HISTORIC DISTRICT COMMISSION ADDITIONAL INFORMATION REQUEST

Application Number: HDC2025-00461

PROJECT ADDRESS: 2011 Orleans Street

HISTORIC DISTRICT: Lafayette Park/Mies van der Rohe

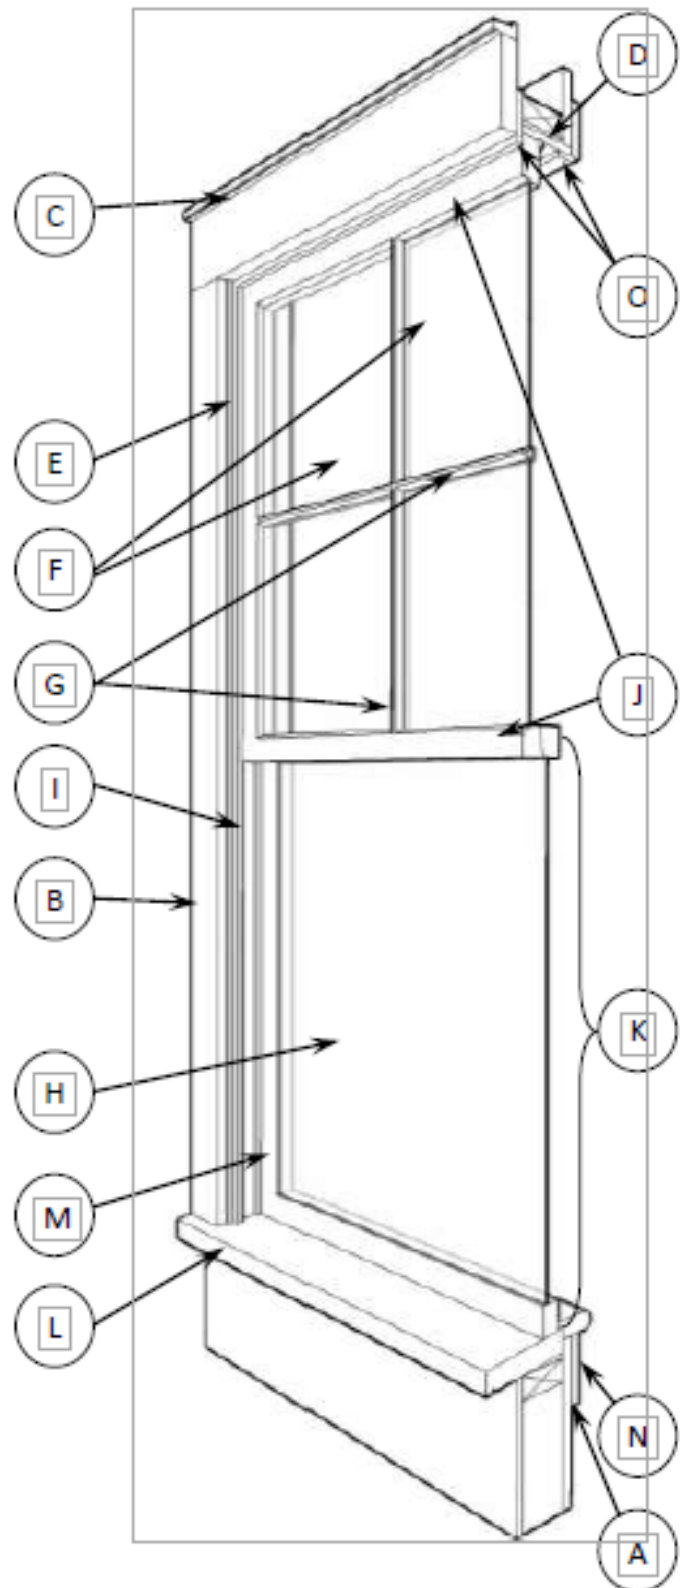
1. Include interior photos of the existing windows.
2. Close-up images showcasing where damage occurs.
3. Section drawings with dimensions and materials of existing windows (see the example drawings attached below).
4. Section drawings with dimensions and materials of the proposed windows.

1. See attached interior photos
2. See attached photos of damaged areas. These photos demonstrate cracked glass, water leakage on floors, inability to lock windows without the use of wood or a bar, seal leakage, lack of argon gas and general failure.
3. See attached images of the patio door which is 84 inches wide by 80 inches tall. The rails are 2.5 inches wide and the rails are 4 inches wide. The picture window is 58" x 58" and is mulled to a bottom gliding one panel window at 58" x 34". The rails and stiles are 2.5". All material is aluminum and/or other metal components.
4. See attached images of the proposed design. Same dimensions apply as in No. 3. The Andersen 100 series material is it's patented Fibrex.
